City of El Paso – City Plan Commission Staff Report

Case No:	SUSU14-00023 – Kern View Estates Unit Two Replat A
Application Type:	Resubdivision Combination
CPC Hearing Date:	April 23, 2015
Staff Planner:	Nelson Ortiz, (915) 212-1606, ortiznx@elpasotexas.gov
Location:	East of Stanton and North of San Mateo
Acreage:	15.5757 acres
Rep District:	1
Existing Use:	Vacant
Existing Zoning:	R-3 / P-R 1/c (Residential / Planned Residential/condition)
Proposed Zoning:	R-3 / P-R 1/c (Residential / Planned Residential/condition)
Nearest Park:	Mission Hills Park (.23 mile)
Nearest School:	Mesita Elementary School (.70 mile)
Park Fees Required:	$83,570.00
Impact Fee Area:	N/A
Property Owner:	Piedmont Group, LLC
Applicant:	Piedmont Group, LLC
Representative:	Brock & Bustillos, Inc.

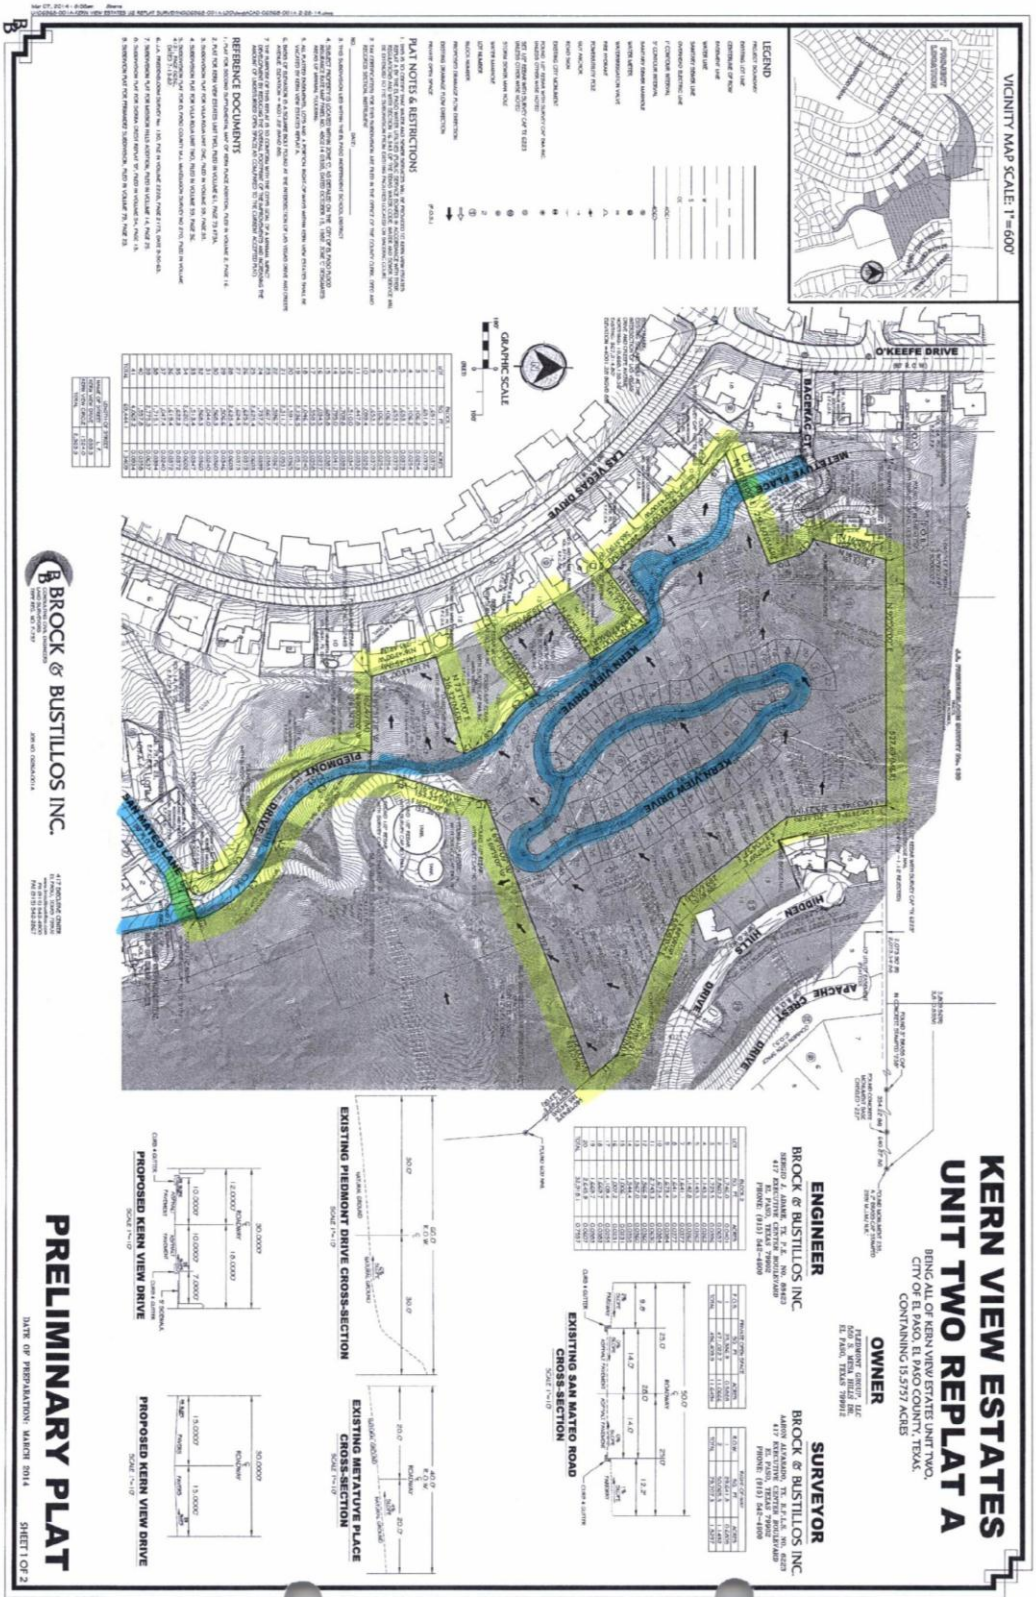
1. Verify line of sight for proposed monuments along drives.
2. On the street cross-sections, need to label the slope and direction.
3. Provide cross section for proposed future private Piedmont Drive.
4. Show proposed drainage flow patterns and contours on the preliminary plat. Identify the discharge location for all storm-water runoff.
5. Verify safe conveyance of the existing watercourse through the developed subdivision and show that all downstream storm-water management facilities have sufficient capacity to carry the additional runoff.
6. Provide a note on the plat indicating the entity responsible for maintenance of private drainage easement and private open space.
